CITY OF ALBUQUERQUE

**RE: 2611 Rio Grande Blvd NW
2617 Rio Grande Blvd NW
2623 Rio Grande Blvd NW
Grading and Drainage Plans
Engineer's Stamp Date: 10/01/2025
Hydrology File: G12D045
Case # HYDR-2025-00364**

Based upon the information provided in your submittal received 10/8/2025, the Grading & Drainage Plan is approved for Building Permit and Grading Permit. Please attach a copy of this approved plan in the construction sets for Building Permit processing along with a copy of this letter.

CG-101

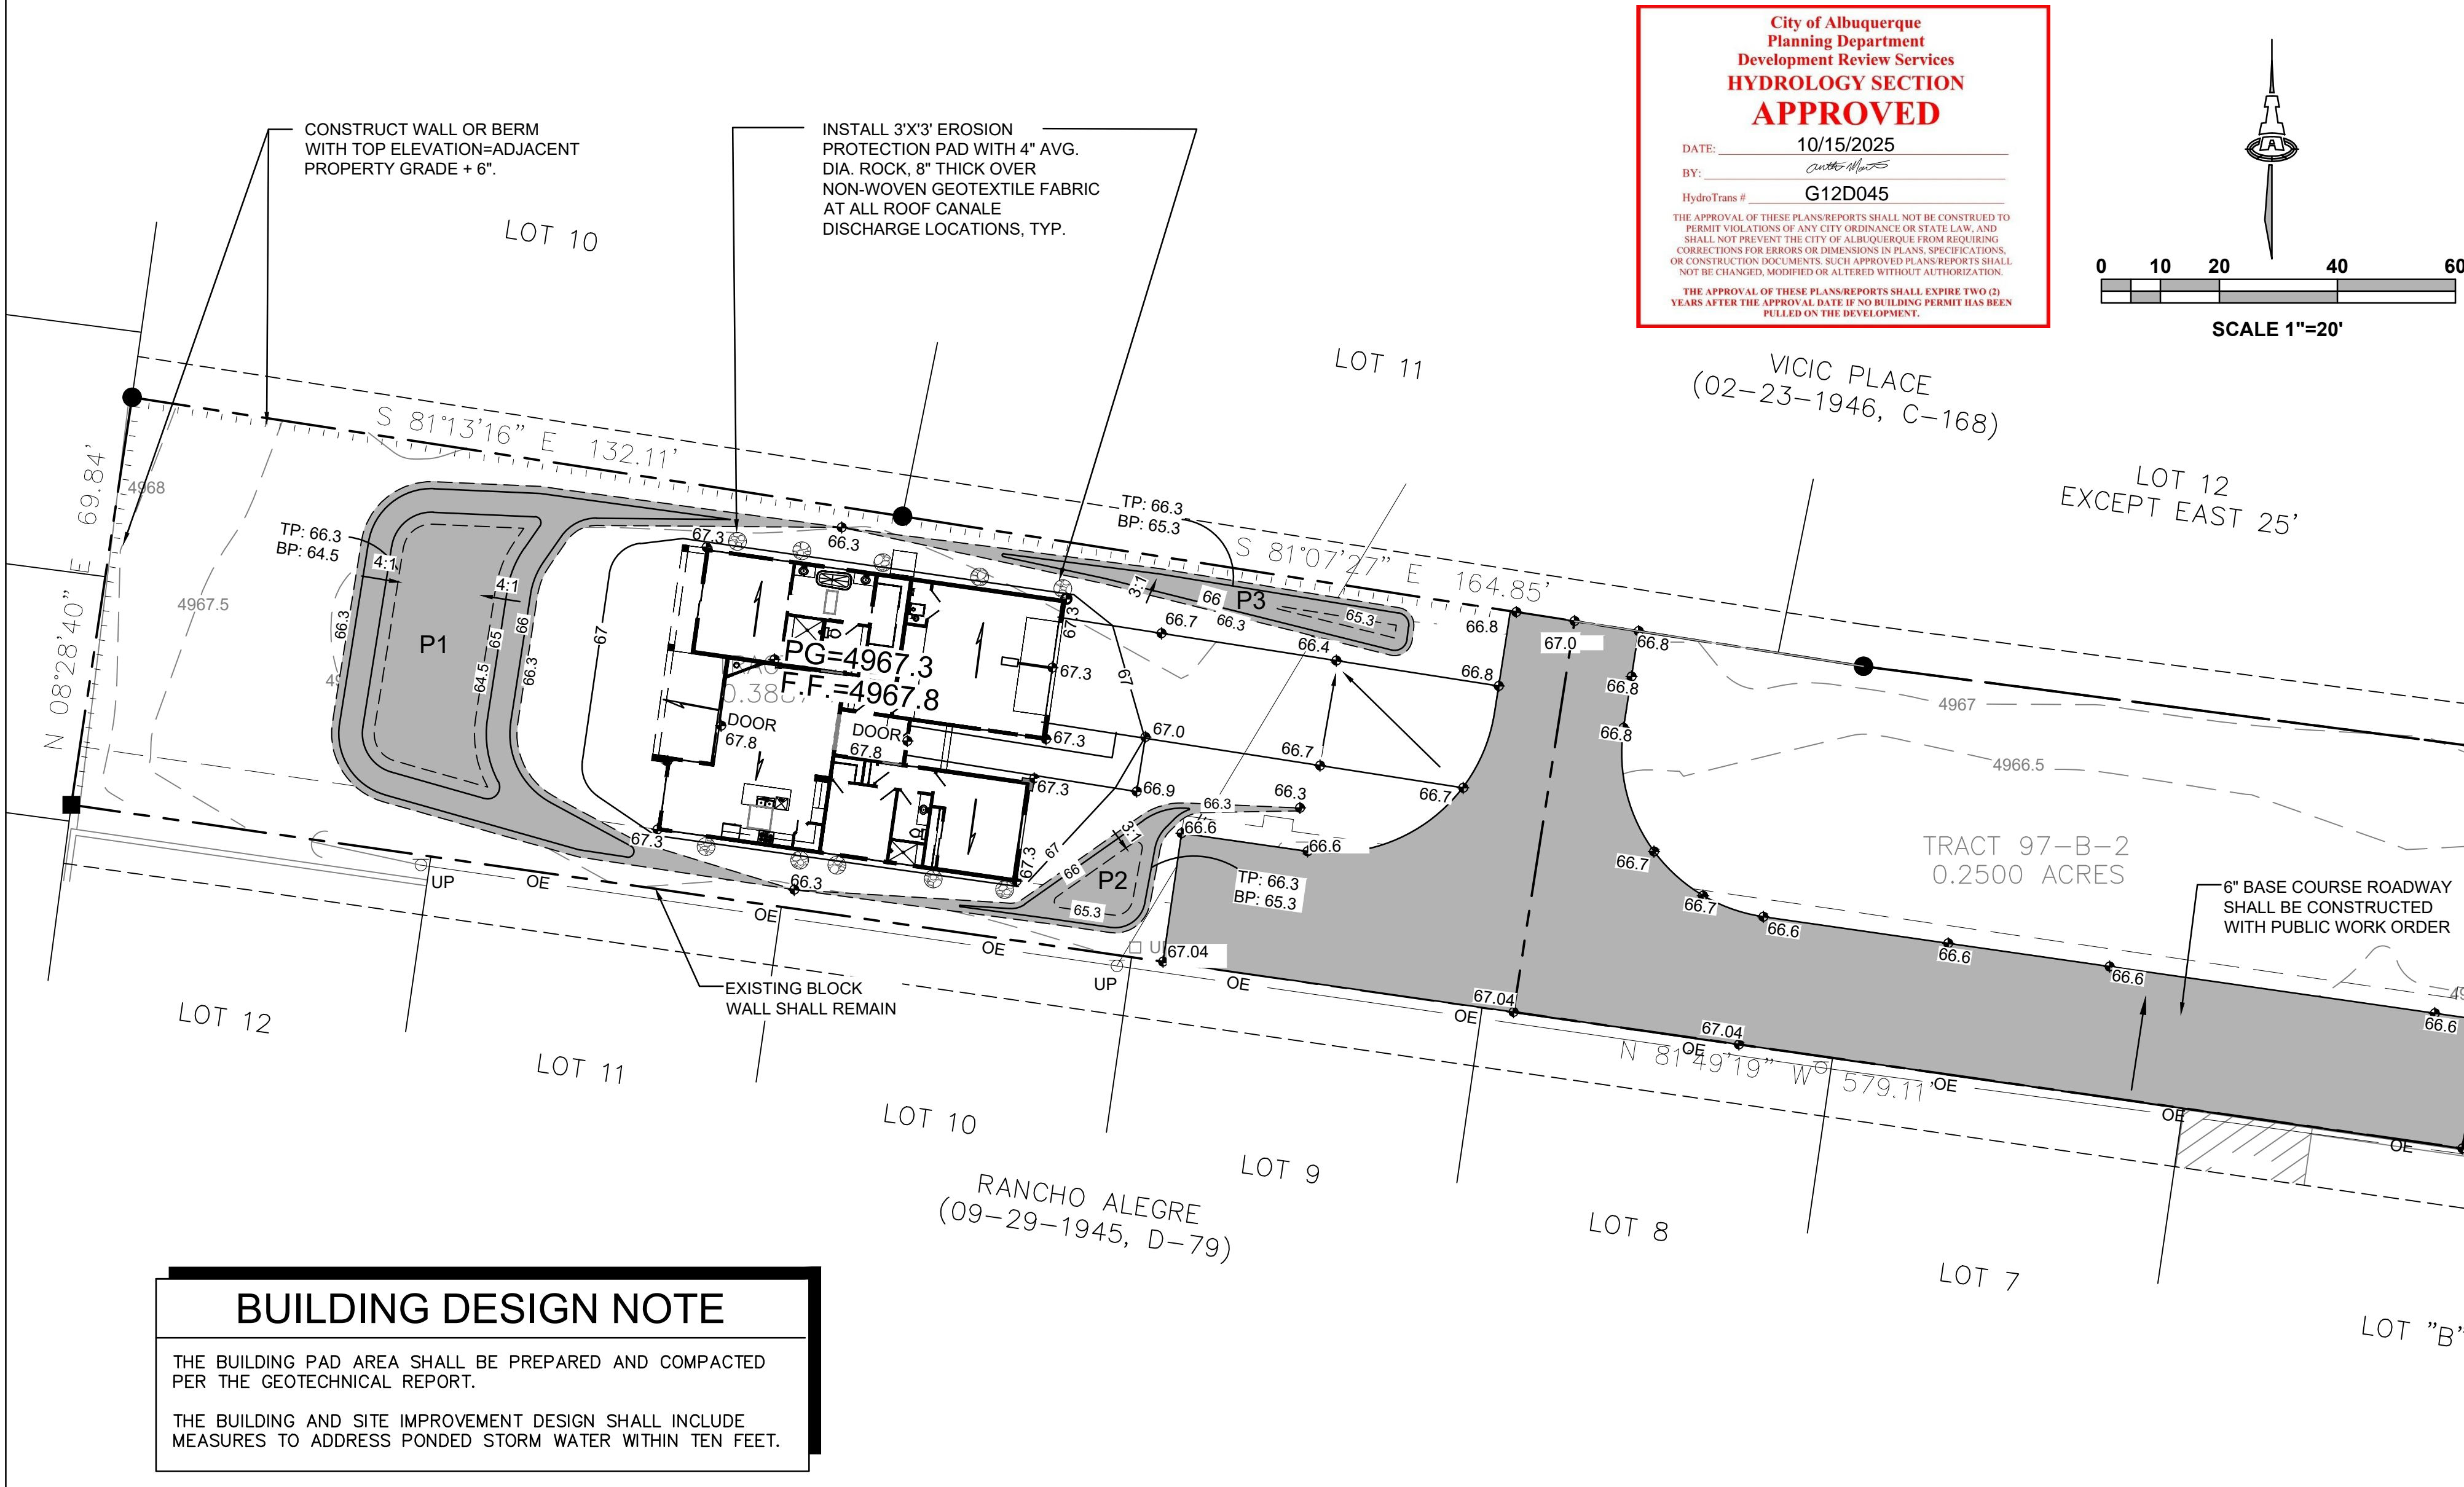
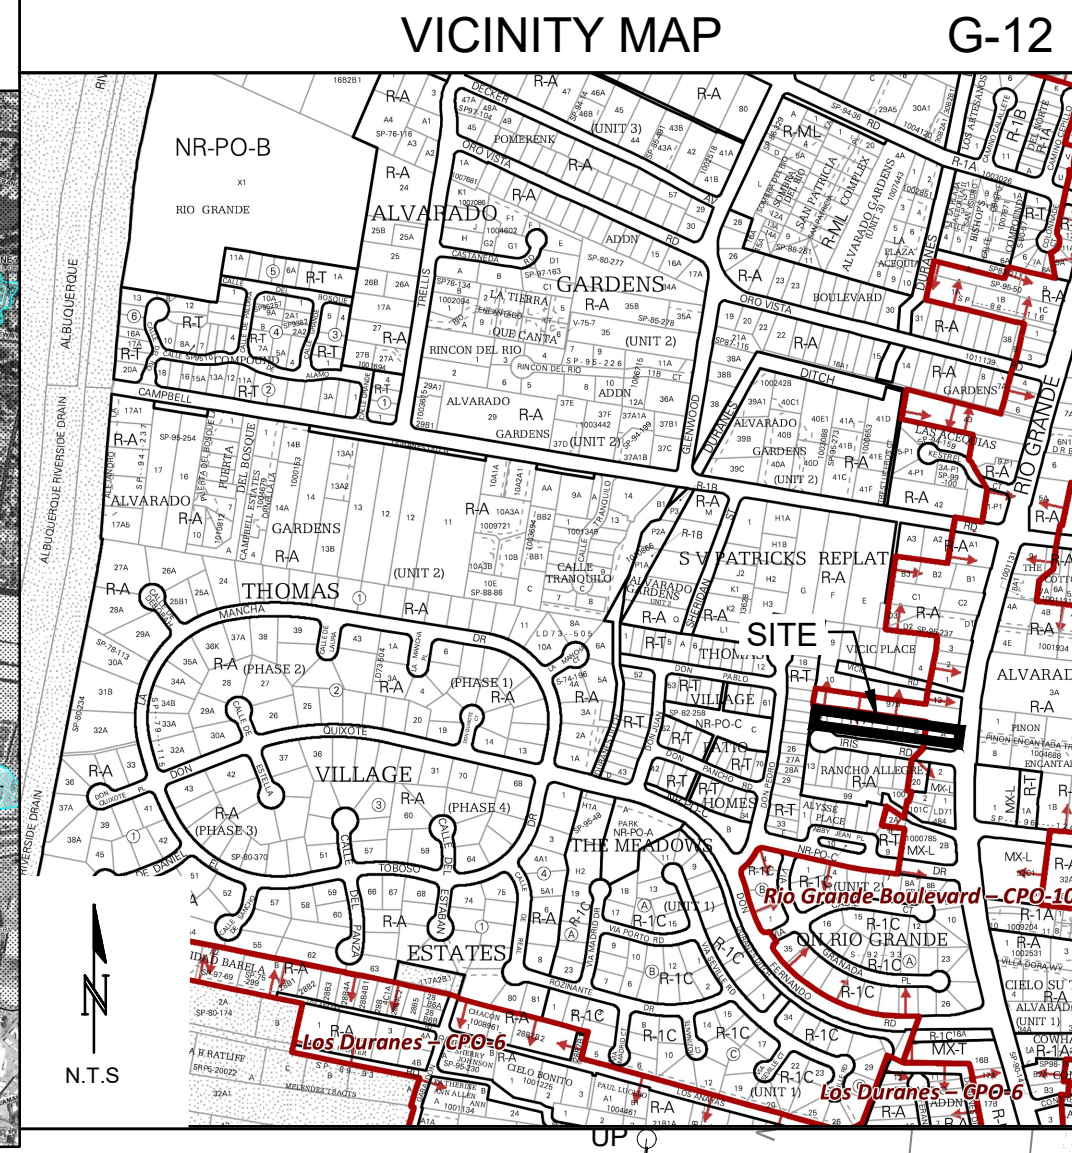
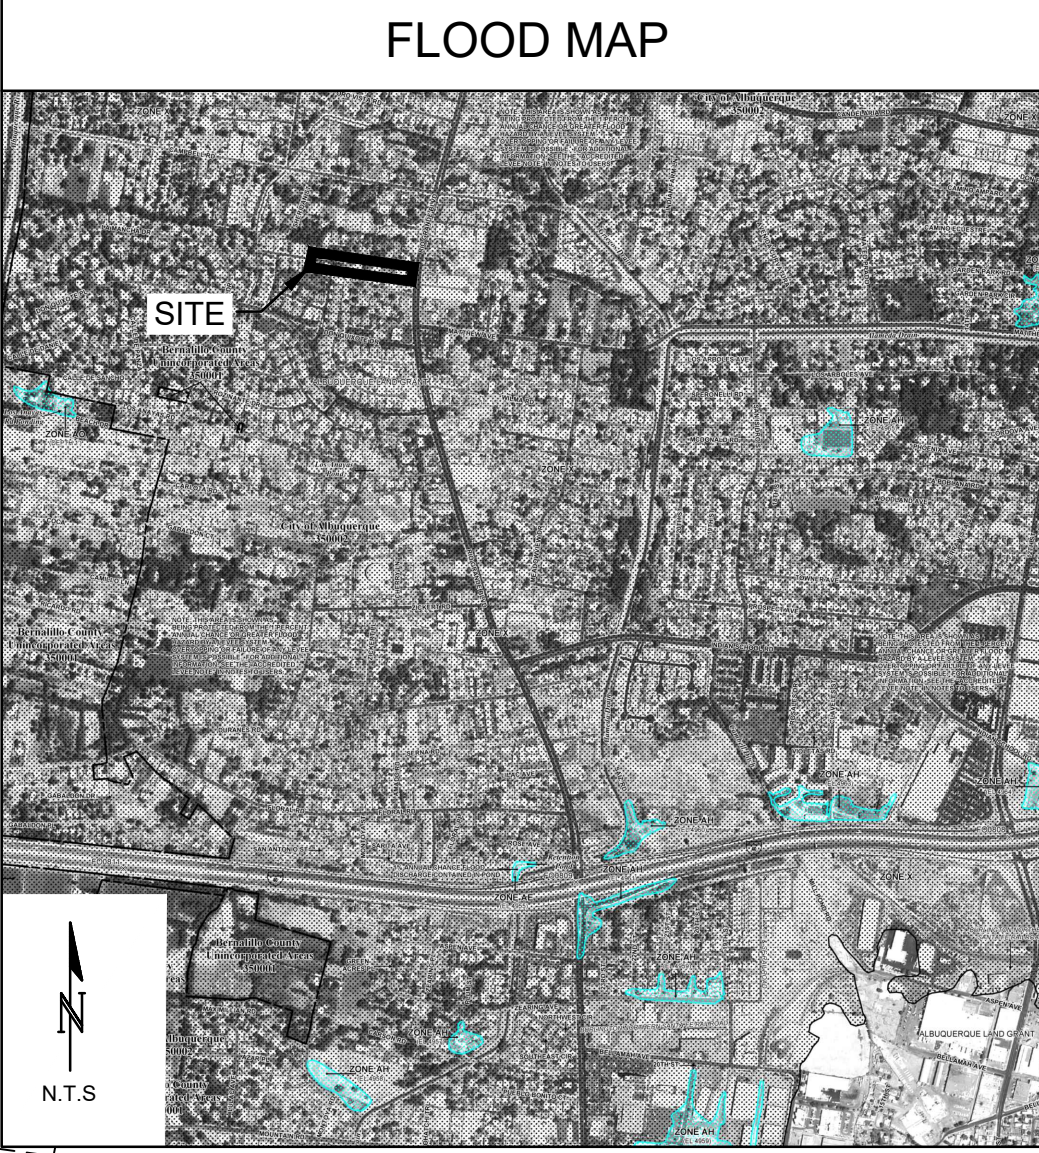
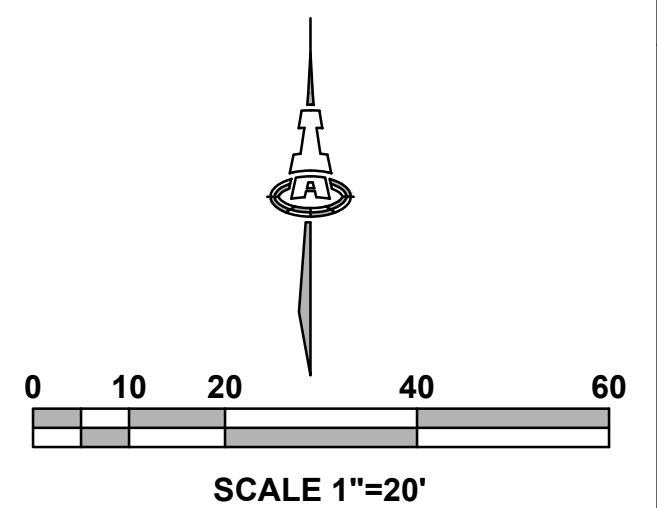
1. Engineer's Certification, per the DPM Part 6-14 (F): *Engineer's Certification Checklist For Non-Subdivision* is required.
2. Please provide the Drainage Covenant with Exhibit A for the stormwater quality ponds per Article 6-15(C) of the DPM prior to Permanent Release of Occupancy. Please submit the original copies along with the **\$ 25.00** recording fee check made payable to Bernalillo County to the Hydrology Section of Development Review Services on the Ground floor of Plaza de Sol. Application for Covenant submittal in ABQ-PLAN is also required.
